OWNER: R.A. RUUD & SON, INC.
 MAPC CASE NO. CU-214
 AND NO. SCZ-0416

OPERATIONAL PLAN
 FOR
 SAND AND GRAVEL EXTRACTION
 AND
 READY-MIX CONCRETE PLANT

RESIDENTIAL DEVELOPMENT PLAN
FOR THE NORTH 1/2 S.W. 1/4 SEC. 3, T29S, R1E

S.W. ¼ SEC. 3 TWP. 29S. R. 1 E.

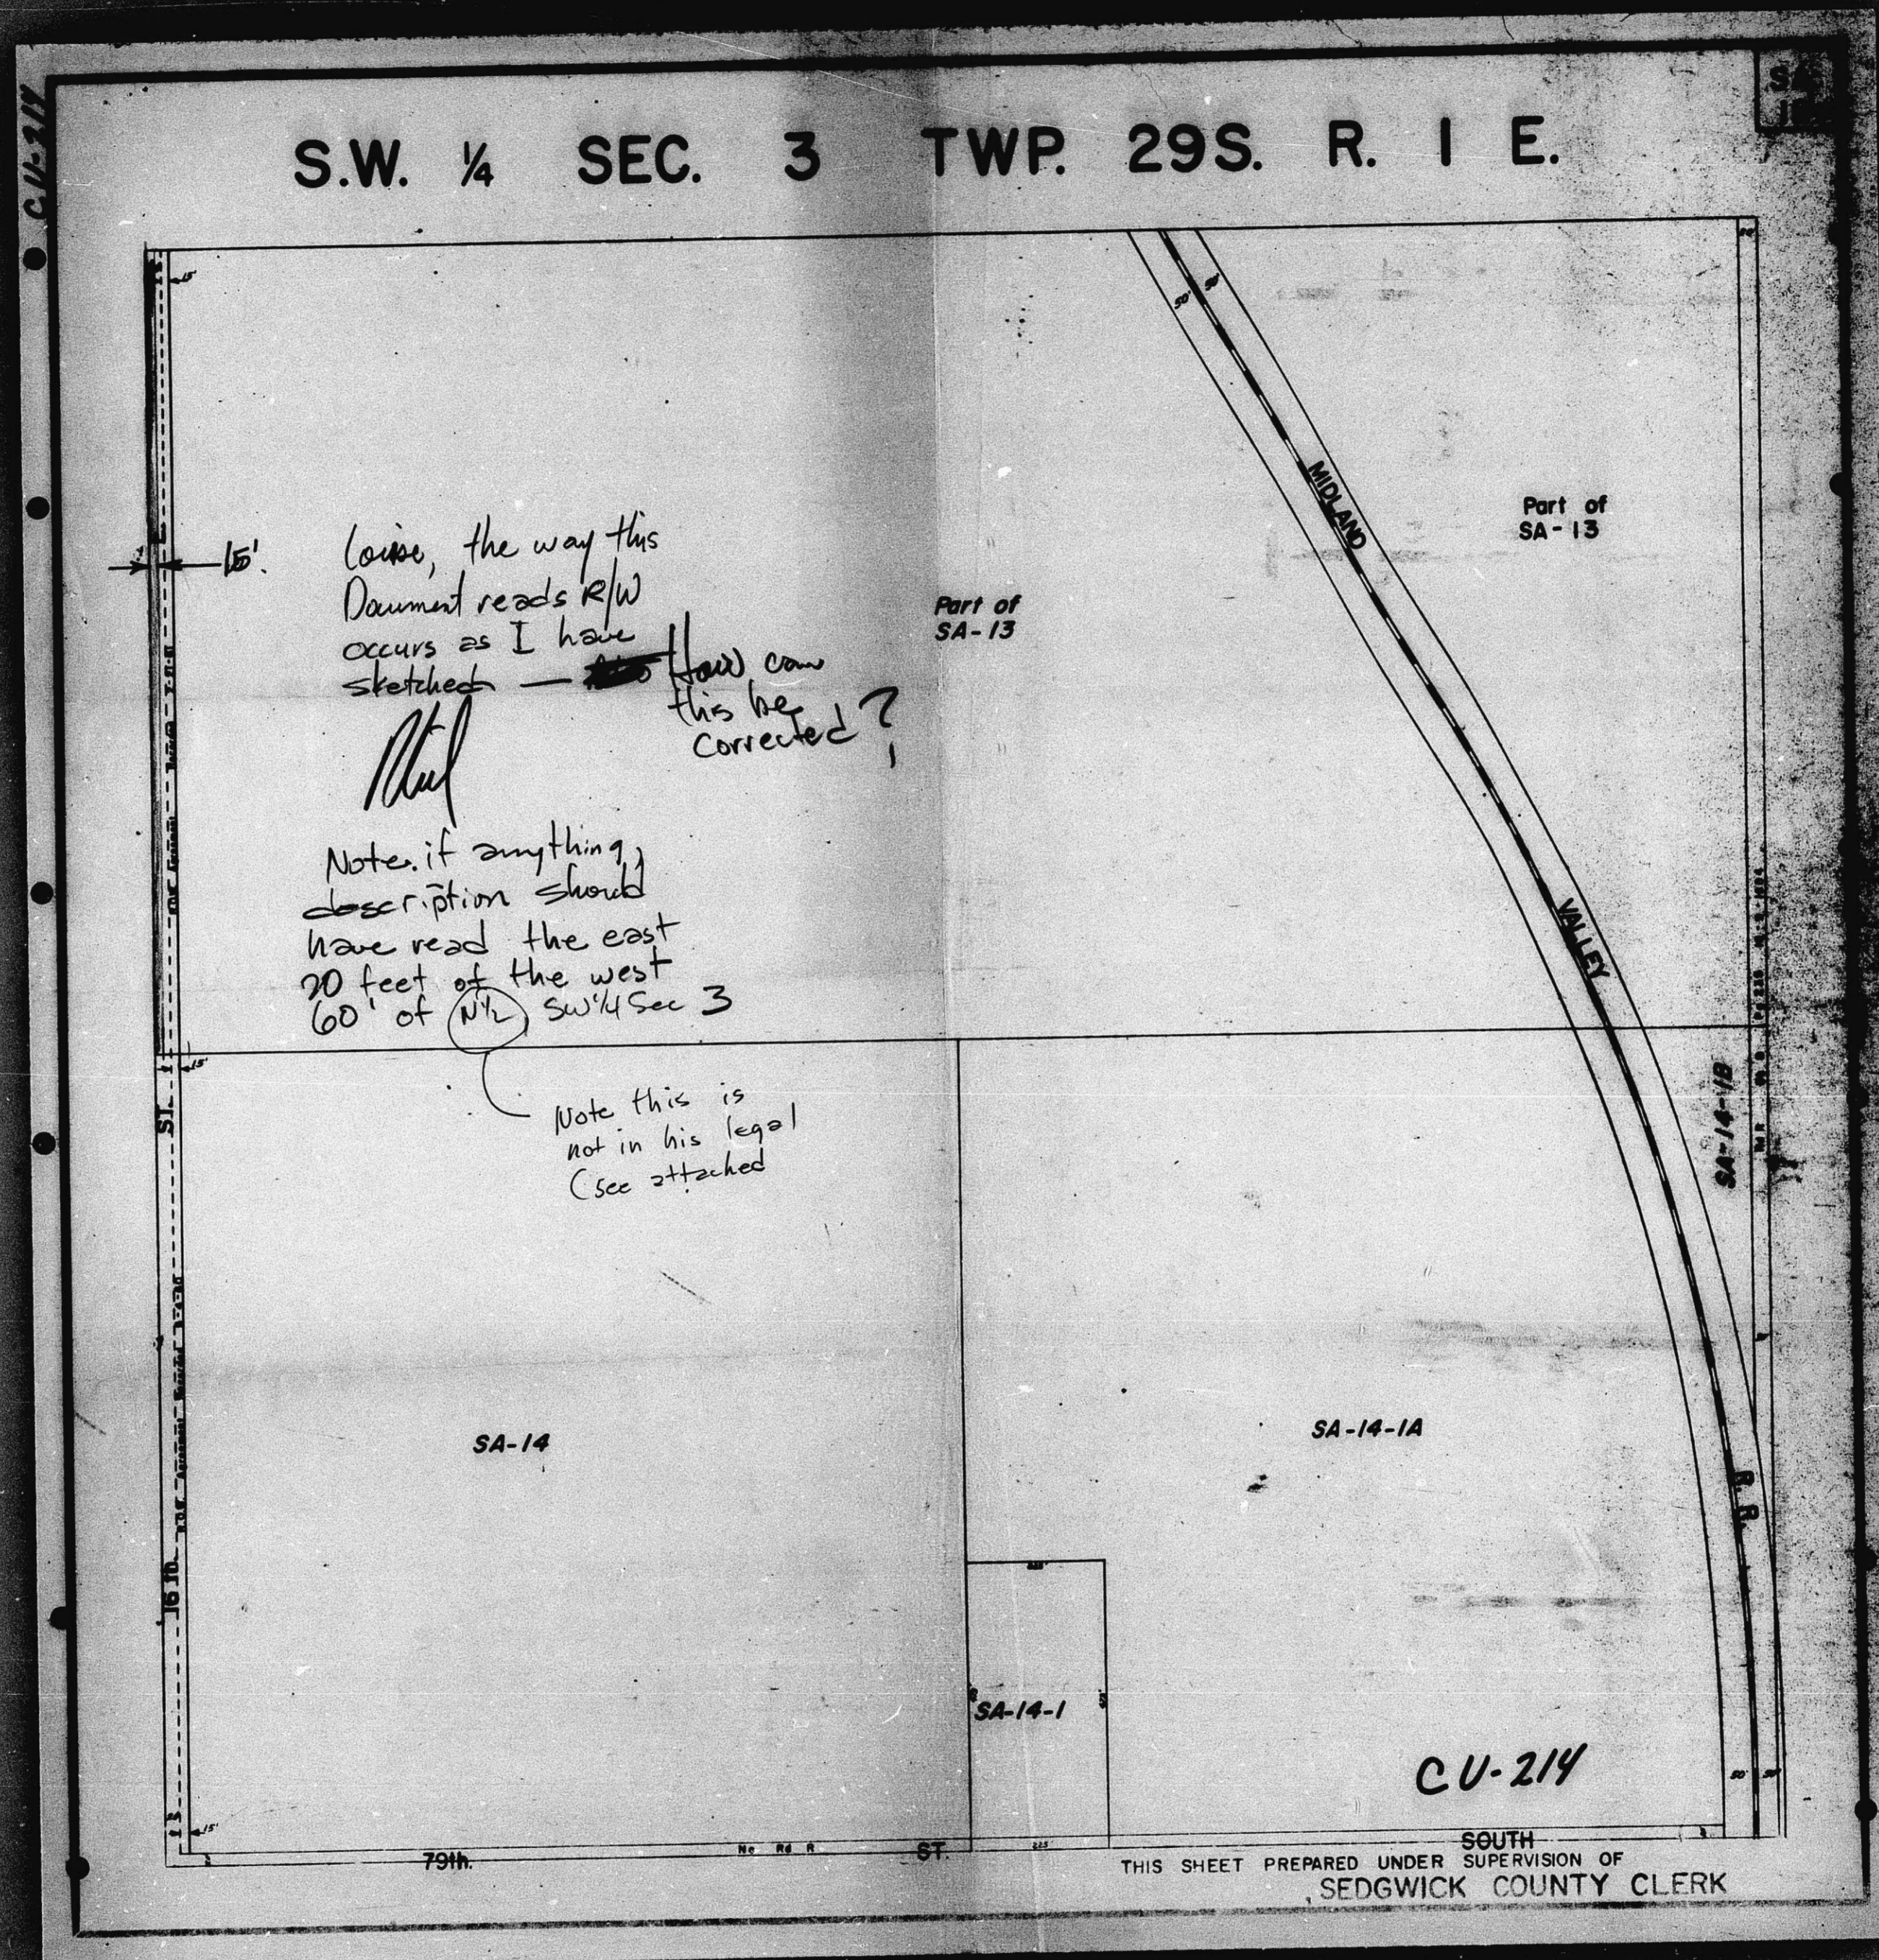
15'
Cause, the way this
Daumont reads R/W
occurs as I have
sketched — ~~150~~ How can
this be
corrected?
Mud

Note, if anything,
description should
have read the east
90 feet of the west
60' of (N^{1/2}) SW ¼ Sec 3

Note this is
not in his legal
(see attached)
